*IEEE 802.3cg*  
10BASE-T1S minimum PSD mask  
*September 10<sup>th</sup>, 2018*

# Eye Diagram: previous vs proposed min PSD

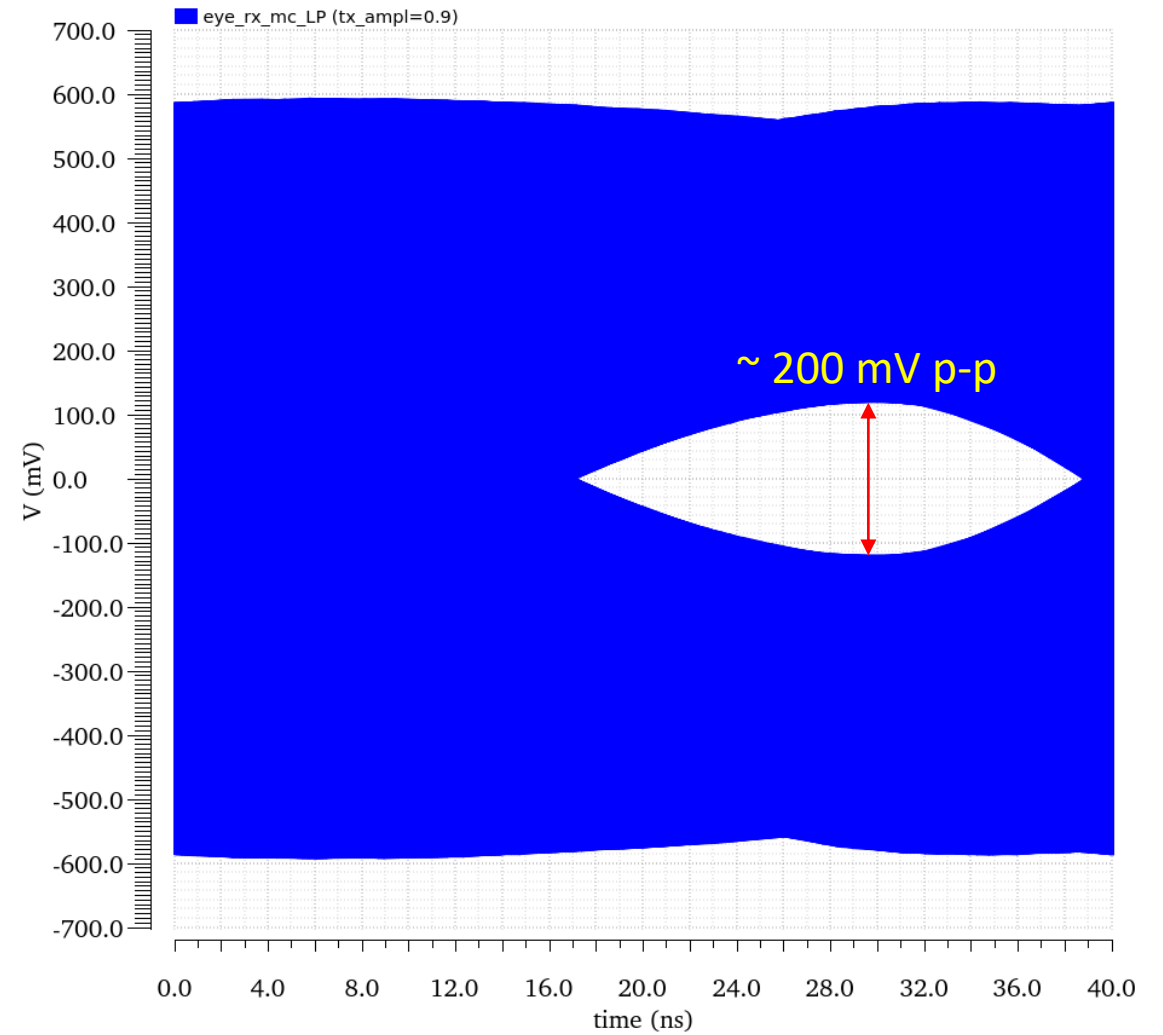
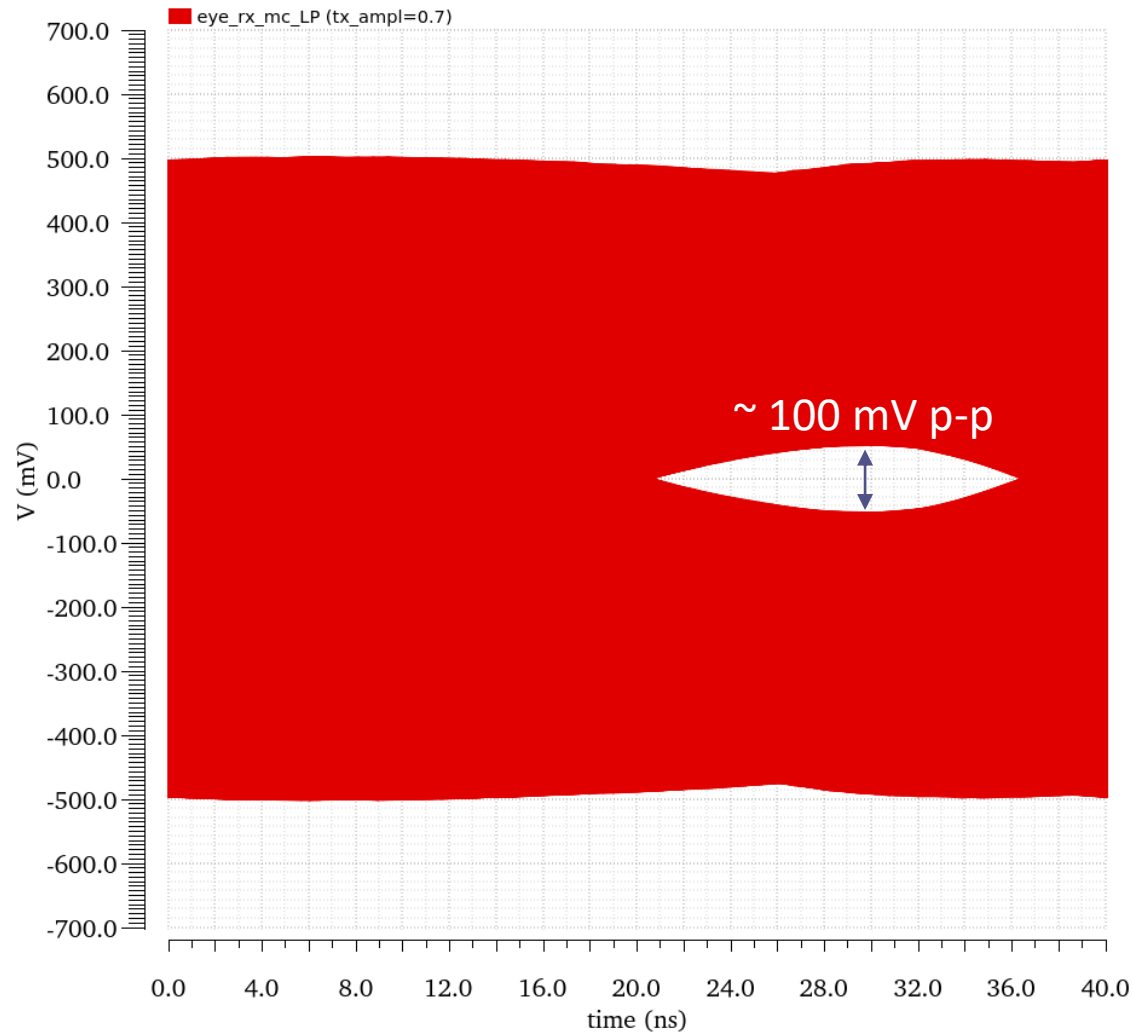
- There have been a lot of discussion in the TF about the upper limit of the PSD mask but not as much for the lower limits.
- Marginalities have been observed under certain conditions when transmitting at lower PSD in presence of automotive environment noise.
- Propose to increase the lower PSD limit by +8db to compensate and gain a safe margin
- See comment #526
